Planning Commission Minutes
April 27, 2023

21. (PUD-1943) Application by OKC L DEV., LLC ~~RSR240, LLC~~, to rezone 9900 Piedmont Road from R-1 Single-Family Residential District to PUD-1943 Planned Unit Development District. Ward 1.

STAFF REPORT
The City of Oklahoma City
Planning Commission
April 27, 2023

(PUD-1943) Application by OKC L DEV., LLC ~~RSR240, LLC~~, to rezone 9900 Piedmont Road from R-1 Single-Family Residential District to PUD-1943 Planned Unit Development District. Ward 1

SITE TOPOGRAPHIC PLAN OF
REDSTONE RANCH NORTH

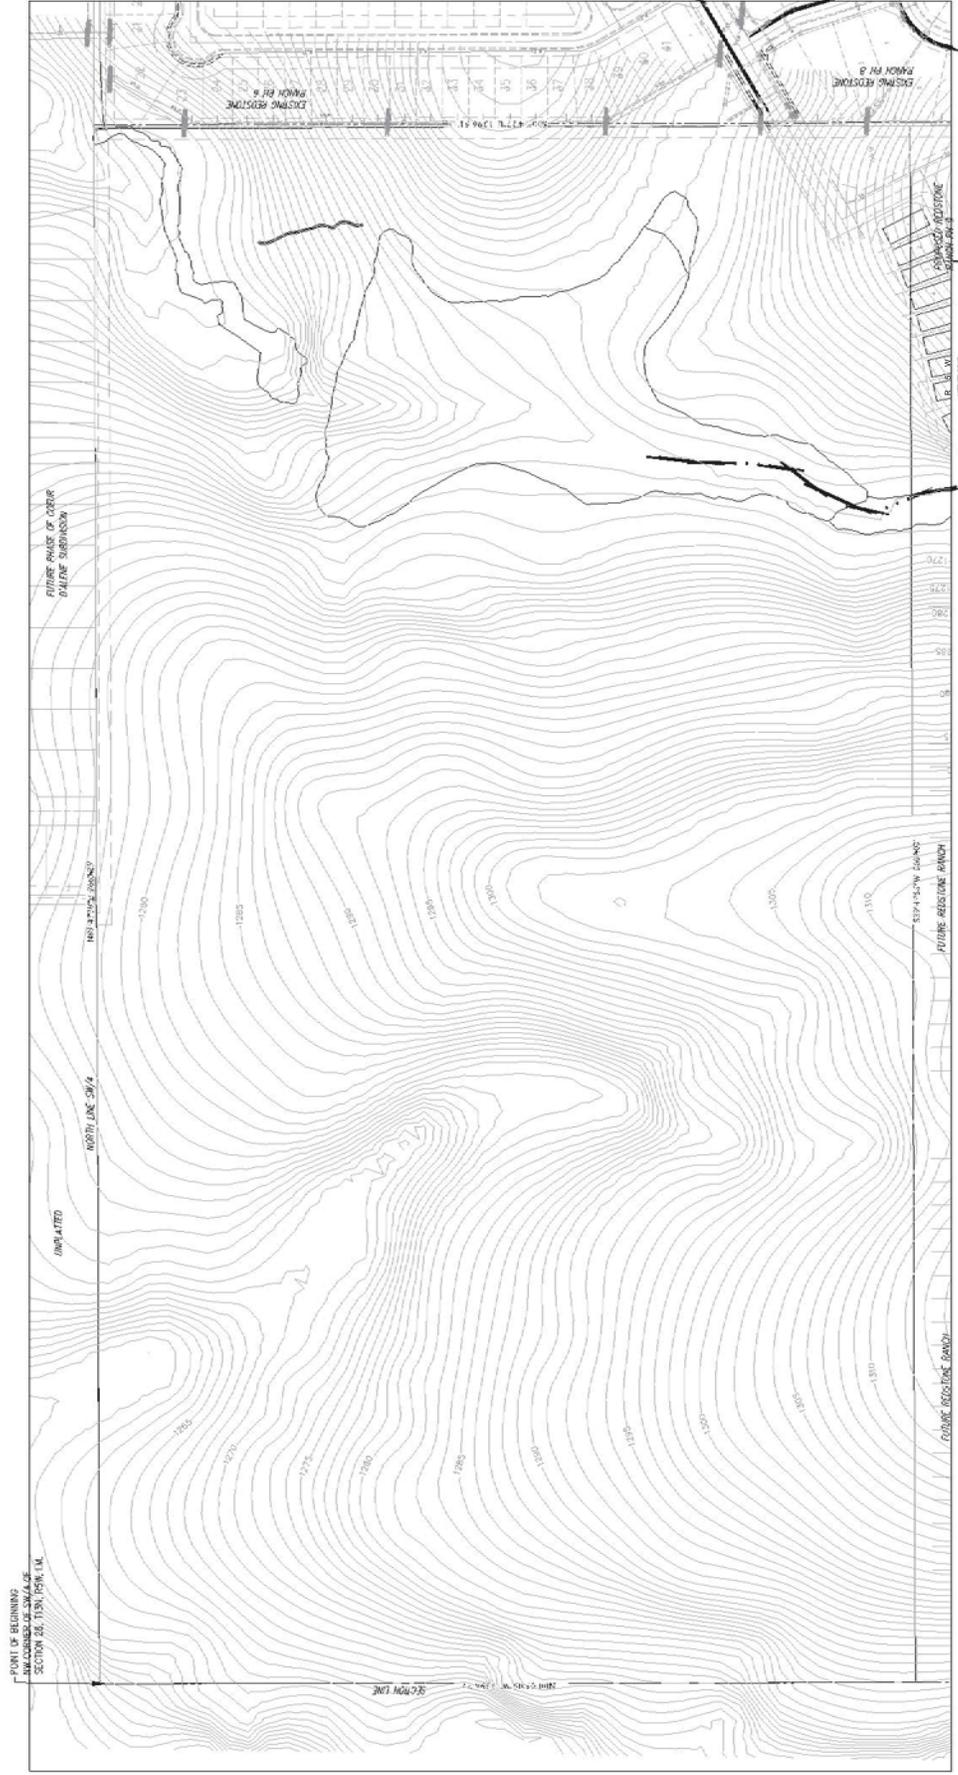
National, state, and local permitting require basic best management practices for stormwater management. Public water and sewer will be extended. It was unclear at the time of review what recreational amenities would be located within the 25 acres of common area. Plan conformance would be strengthened by providing a trail system throughout the neighborhood. The associated Preliminary Plat of Redstone Ranch North (C-7552) indicates 400 lots for a density of 4.68 du/acre.

The subject site is located east of N Piedmont Road and north of W Britton Road. The site is zoned R-1 and was previously platted per the R-1 District regulations, which require minimum 6,000 square foot lots. The new PUD would rezone 85.44 acres into a new PUD to allow reduced residential lot sizes on two tracts. Tract 1, the 57 acres in the center of the site, proposes lot sizes of 4,800 square feet and 40-foot lot widths. Tract 2, the 27.85 acres on the west along Piedmont Road, proposes minimum lot sizes of 3,600 square feet and 30-foot widths, except along N Piedmont Road where lots would be required to meet the R-1 regulation of 6,000 square feet and 50-foot lot widths. The associated Preliminary Plat of Redstone Ranch North indicates the eastern third of the site (21 acres) will be common area/drainage.

The site is located in far west Oklahoma City, at the edge of the Urban Low Intensity LUTA. The proposed 400 lots over 85.44 acres would be a gross density of 4.68 dwelling units per acre, within the LUTA range. At least 25 acres of common area is proposed as indicated on the preliminary plat, but not specified in the PUD Master Design Statement. If the proposed lot sizes are allowed, the MDS should specify at least 20 percent of the PUD site will be open space/common area. Additionally, an internal trail/pedestrian network should be provided for residents in both tracts to connect to and through the common areas.

1. A minimum of 20 percent open space shall be provided within the PUD.
2. An internal pedestrian trail system shall be provided between tracts and to Common Areas A and B.
